## > Customer Product Information (CPI)

**No.:** PN21-066

**Datasheet drawing unification of SEMIPACK 2 modules**

**Subject of change:** SEMIPACK 2 datasheet drawing

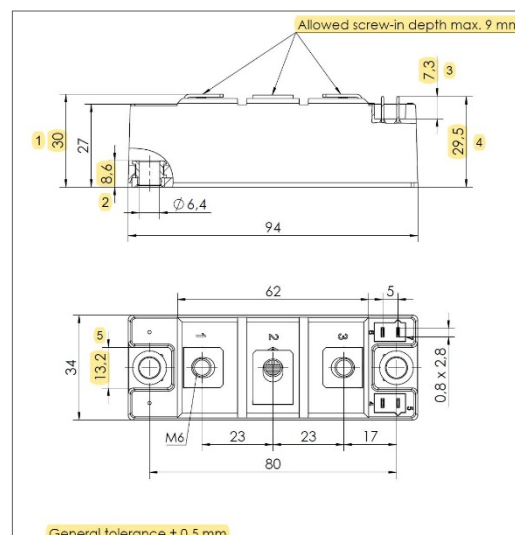
Errata of datasheet drawing and addition of general tolerance in some SEMIPACK 2 data sheets

Changes:

- 1) old  $30^{+0.2}\text{mm}$  → new 30mm with general tolerance
- 2) old 8.3mm → new 8.6mm
- 3) old 6mm → new 7.3mm
- 4) old 29mm → new 29.5mm
- 5) old 13mm → new 13.2mm

The dimension of terminal hole depth is replaced by maximum screw-in depth

Unification of SEMIPACK 2 datasheet drawings. Adjustment of some incorrect dimensions and wrong module height tolerance.
